AMENDMENT OF SOLICITATION/MODIFICATION OF CONTRACT				1. CONTRACT ID CODE		PAGE OF PAGES		
2. AMENDMENT/MODIFICATION NO.			3. EFFECTIVE DATE		4. REQUISITION/PURCHASE REQ. NO.		5. PROJECT NO. (If applicable)

4. Delete Sheets G-001, P-104, M-101, M-504, M-602, MI105, and MI108 and replace with the attached Sheets G-001, P-104, M-101, M-504, M-602, MI105, and MI108.

REPAIR BEQ HP510

PROJECT NO.: 18-0042

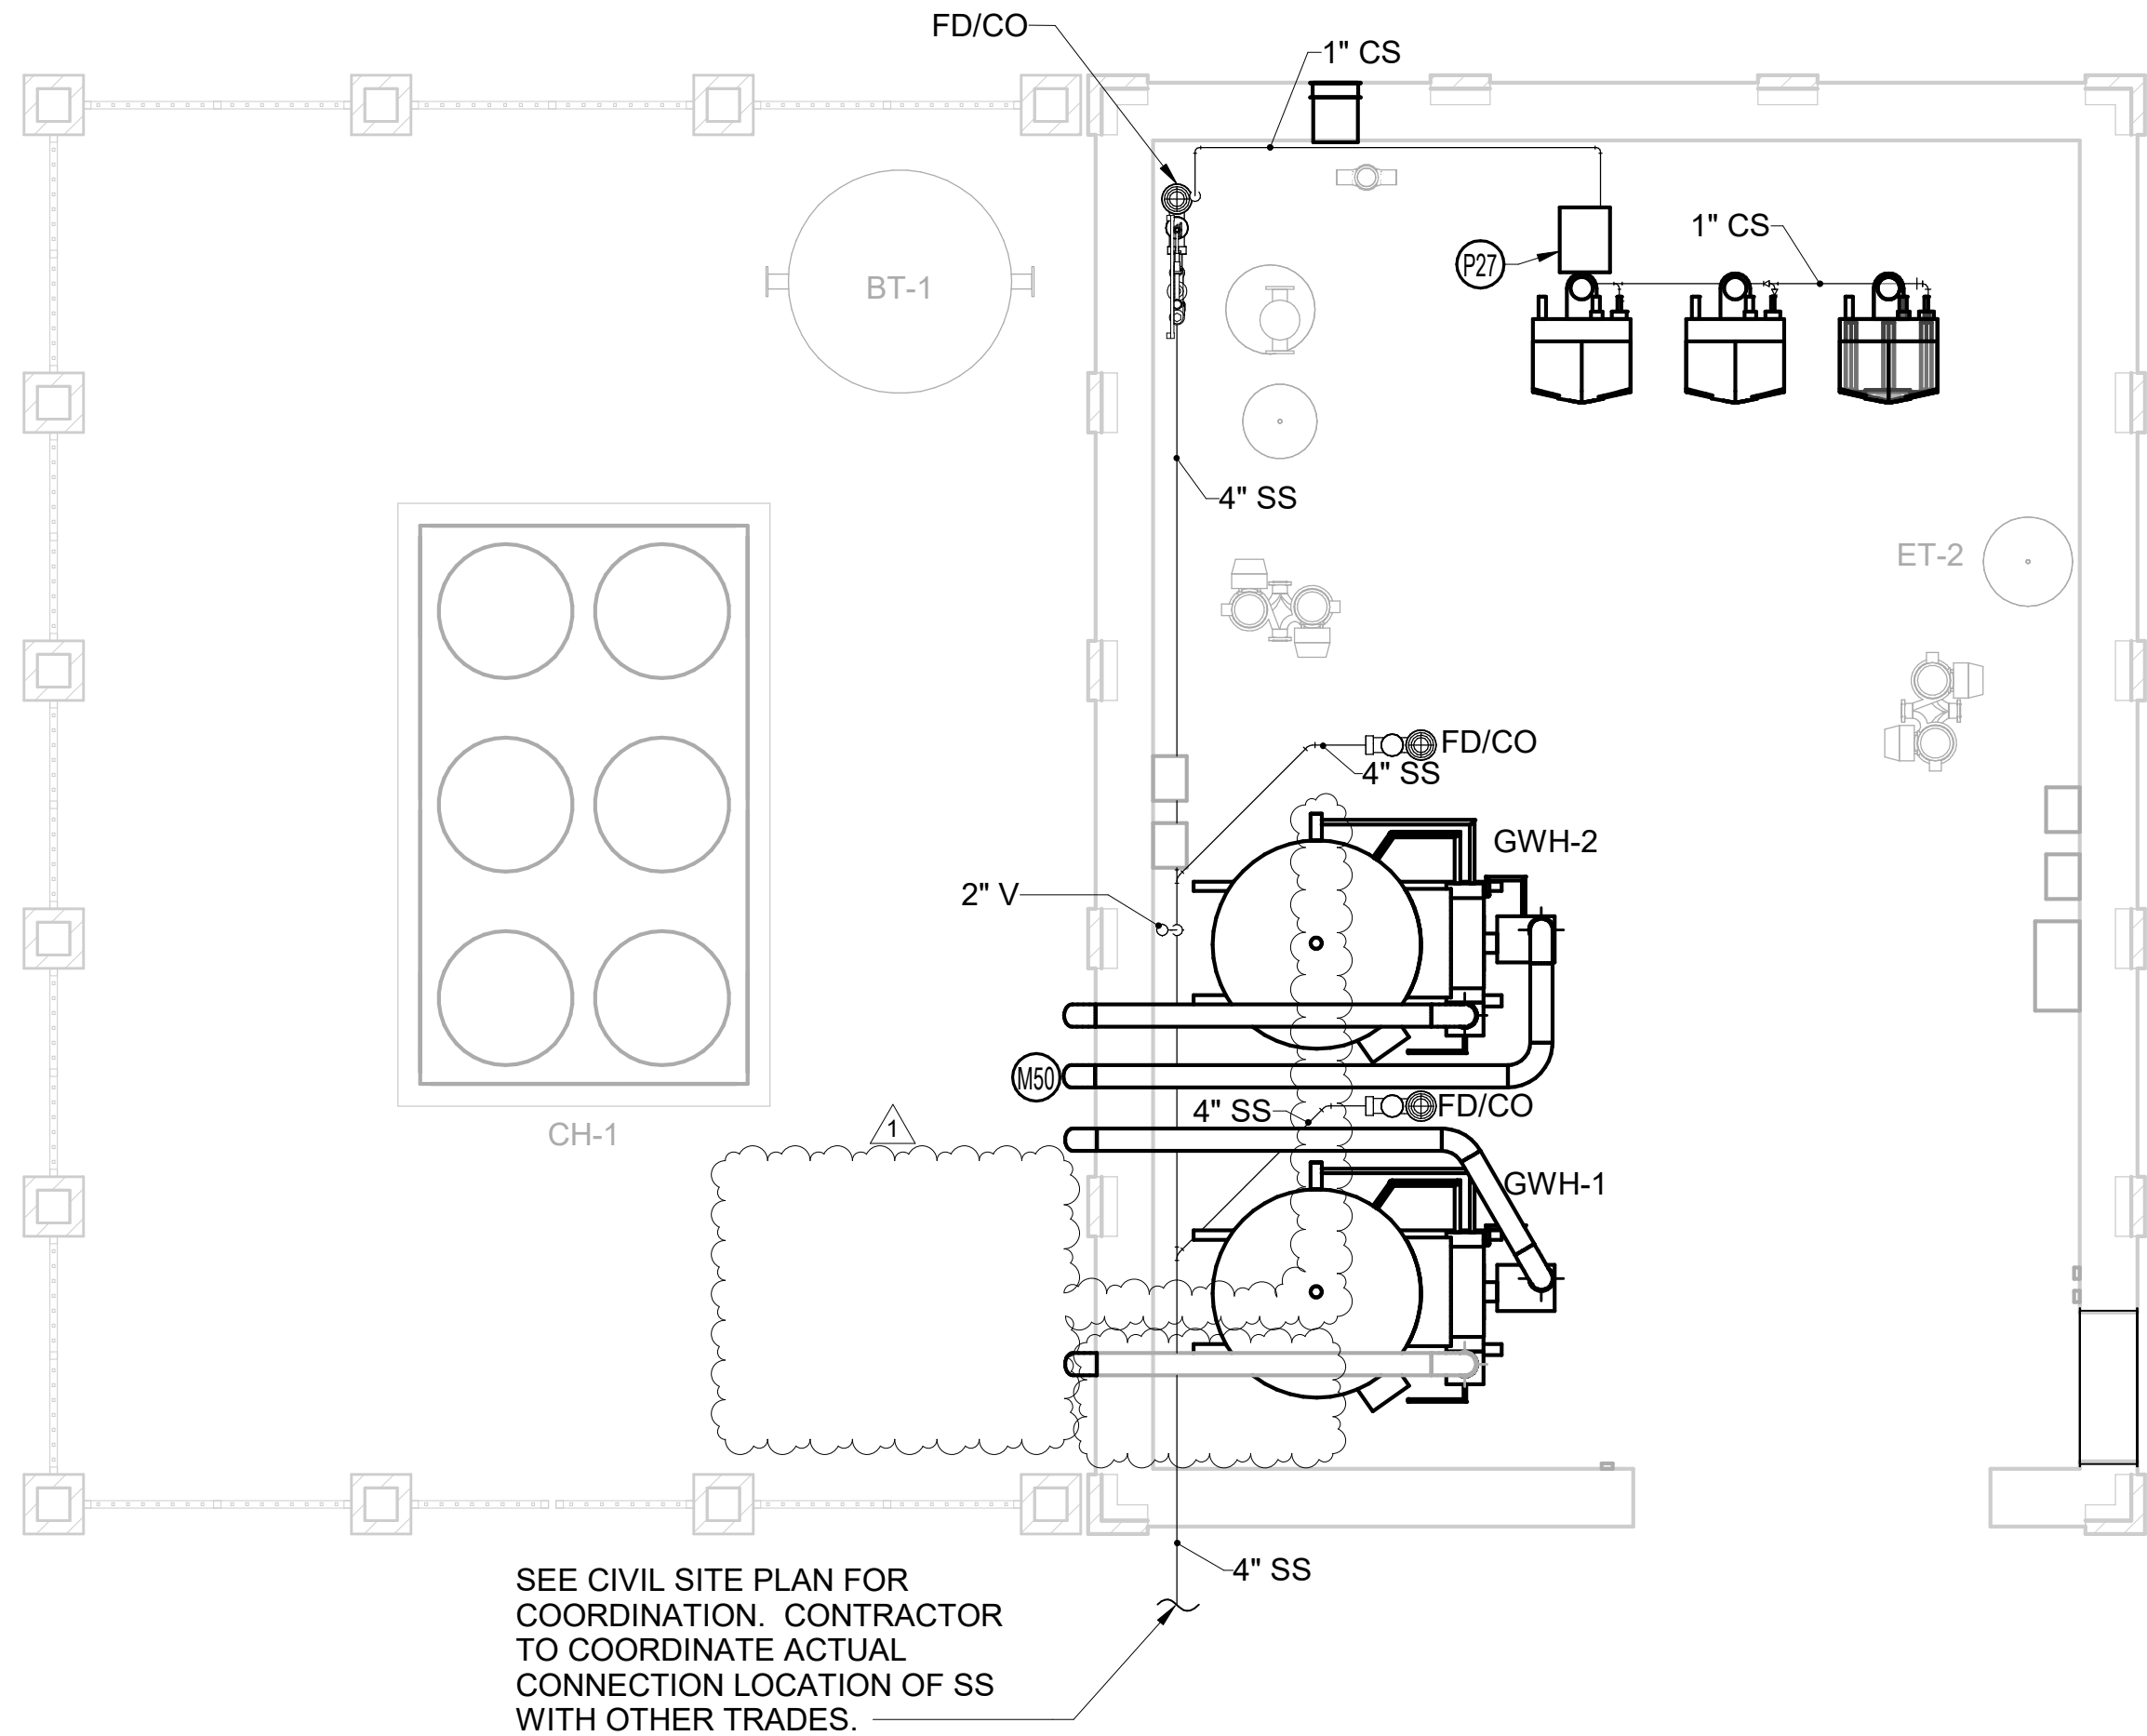
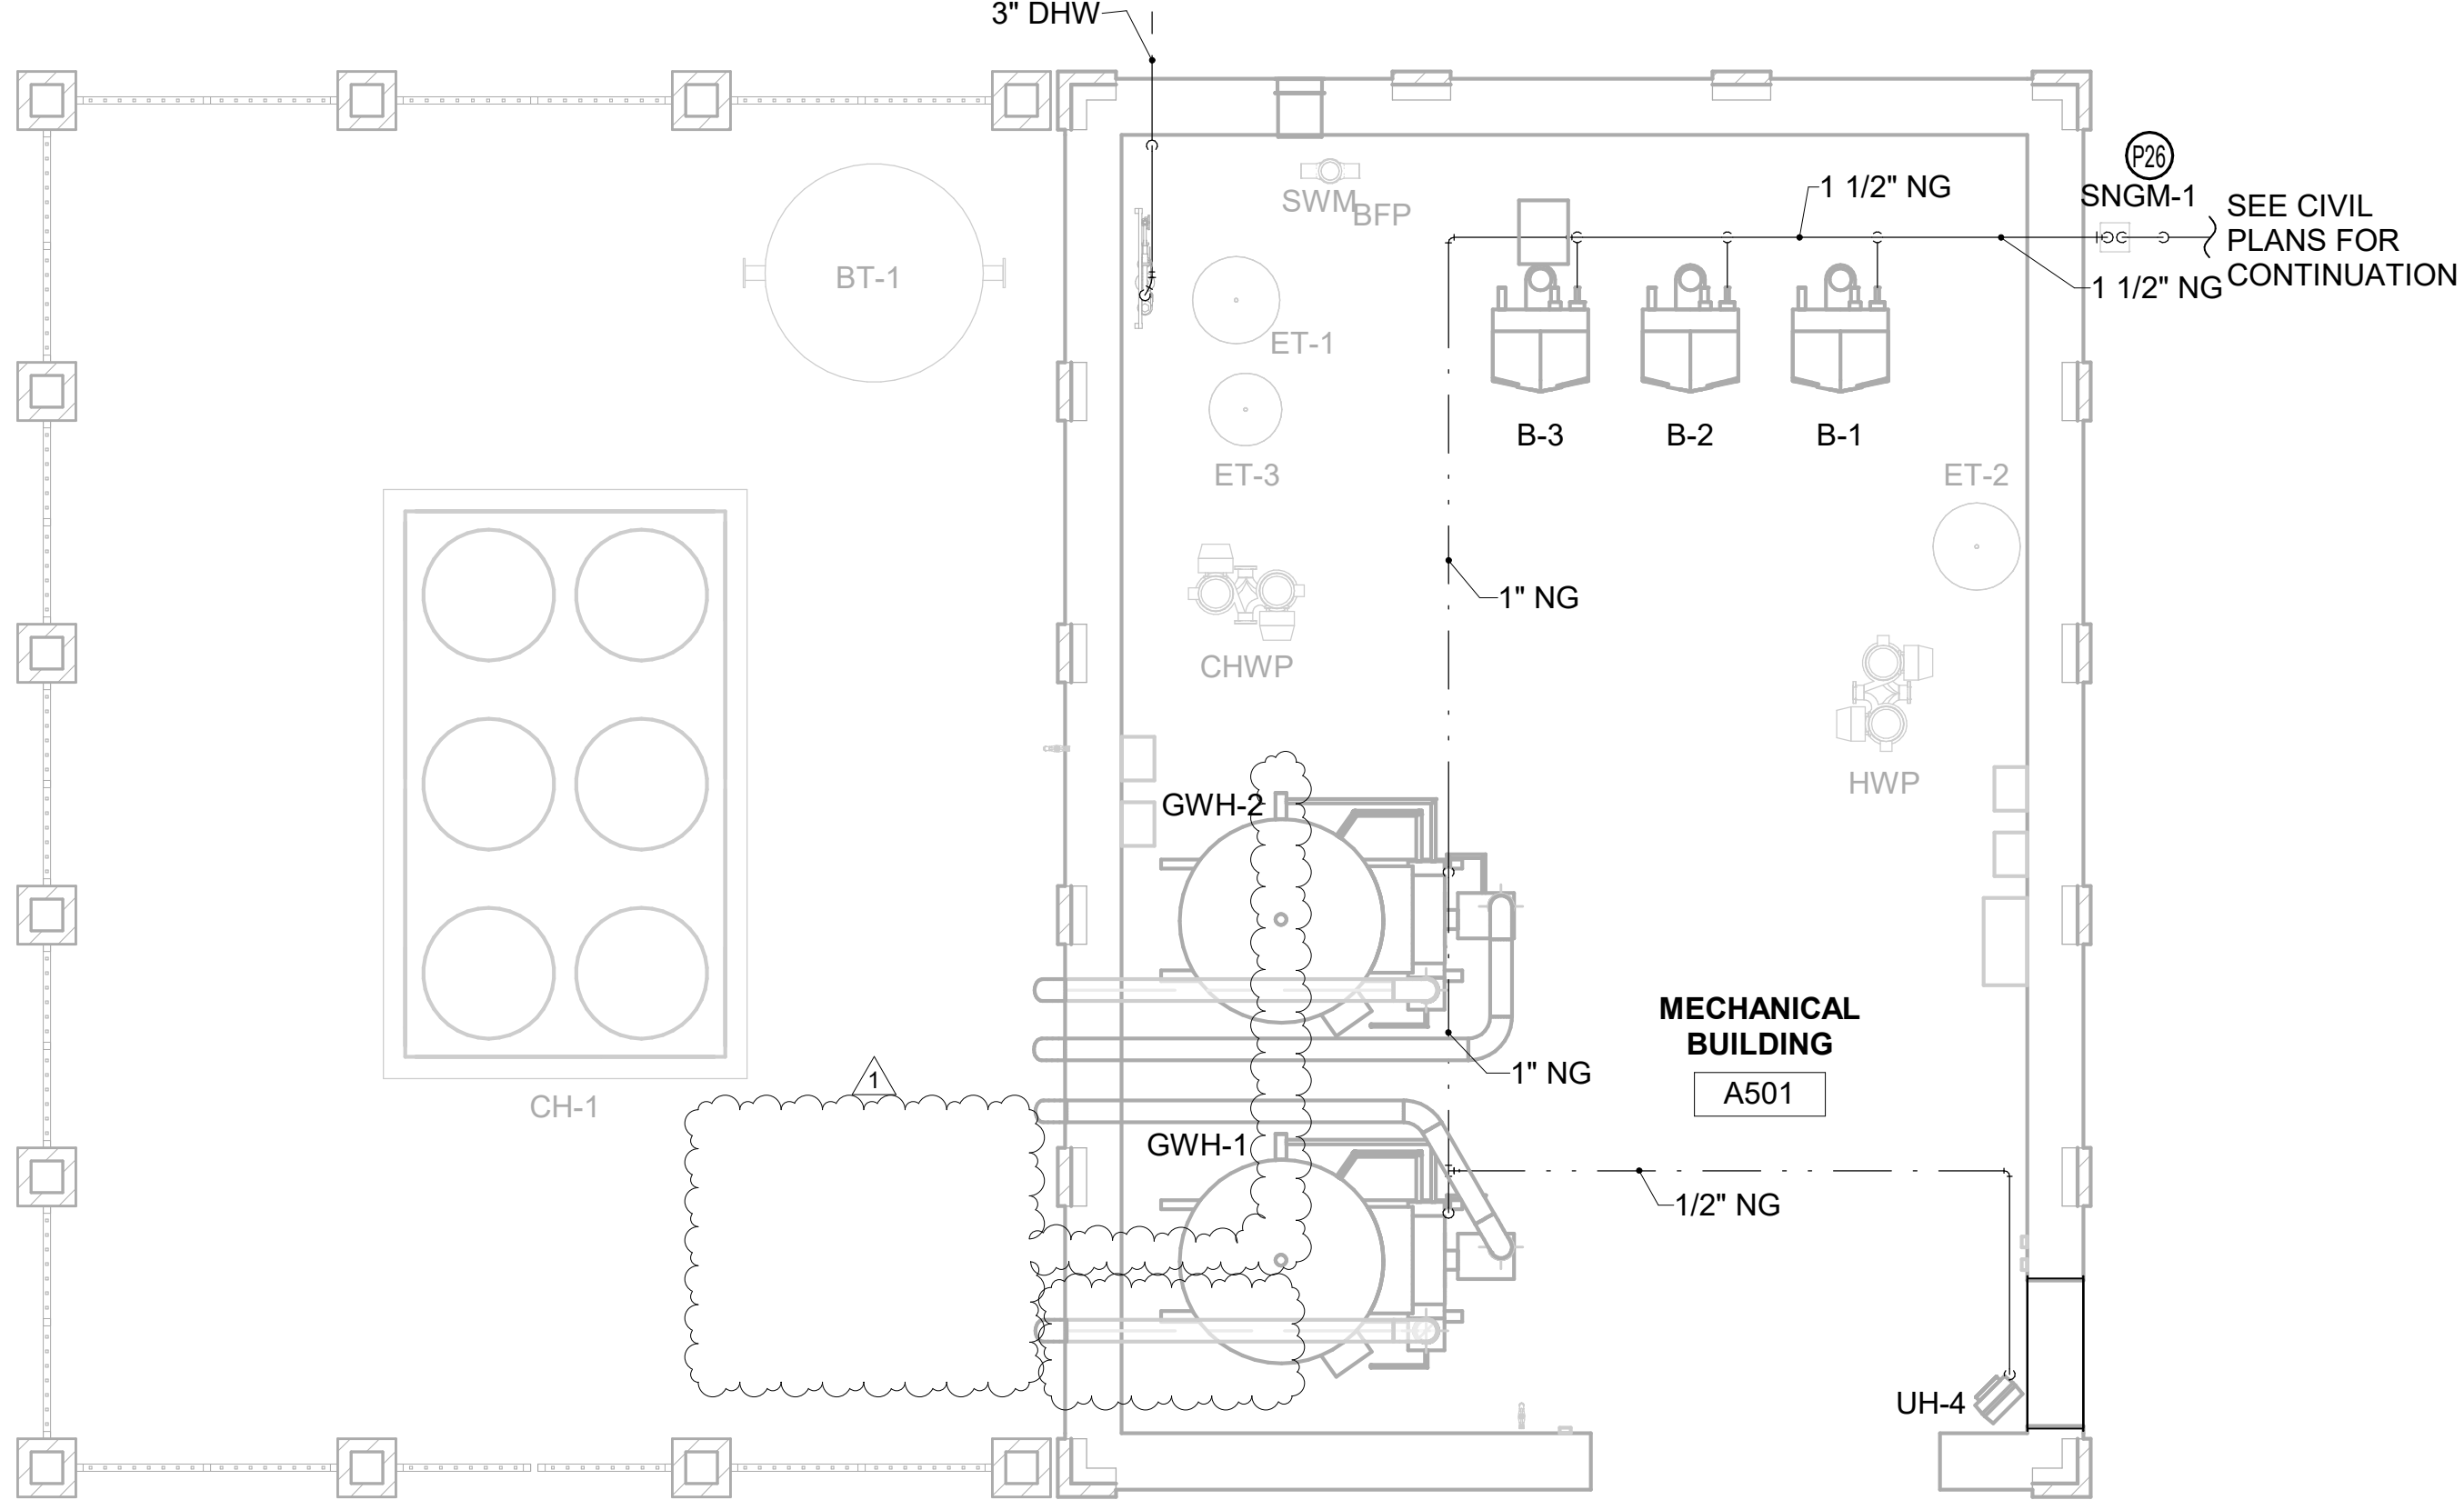
REVISIONS			
SYM.	DESCRIPTION	DATE	APPROVED
1	REMOVE ALL HEAT RECOVERY SYSTEMS	08/10/20	PCM
